DEVELOPMENT REVIEW BOARD REPORT

Meeting Date: November 3, 2022
General Plan Element: *Character and Design*
General Plan Goal: *Foster quality design that enhances Scottsdale as a unique southwestern desert community.*

Minnezona Lofts 45-DR-2021	Request for approval of a new 2-building, 3-story-tall, 9-unit condominium development, with approximately 22,354 square feet of building area, with a proposed amendment to reduce the required setback by 10 percent, on a +/- 0.29-acre site.
---------------------------------------	--

2 STREET-FACING ELEVATION
1/4" = 1'-0"

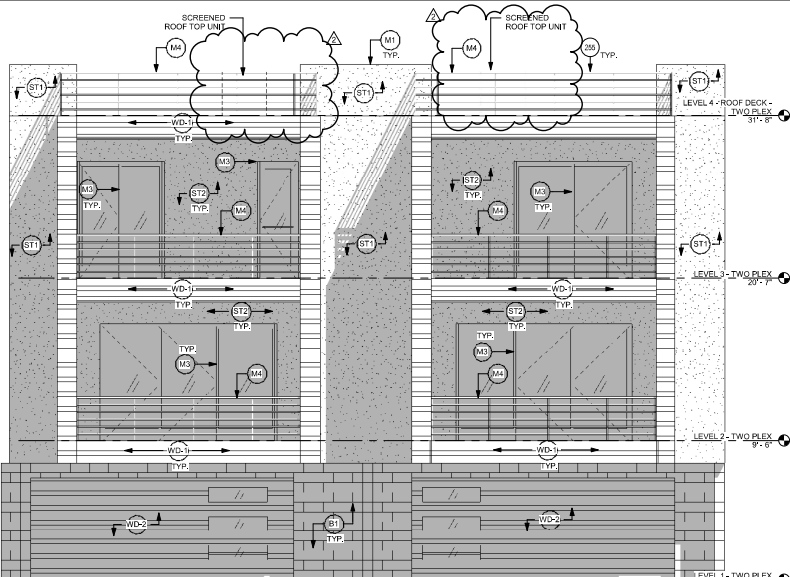
- Amended Property Development Standards – Stepback reduction
- Orientation of the main building entrances should face E. Minnezona per the OTSUDAG
- The facades of buildings facing the street should incorporate articulated architectural features per the OTSUDAG

- *Staff finds that the proposed material, color and finishes are consistent with the Scottsdale Sensitive Design Principles and the OTSUDAG. Architectural details respond to the context of adjacent land uses including similar materials and colors. However, the facades of buildings facing the street should incorporate articulated architectural features per the OTSUDAG*
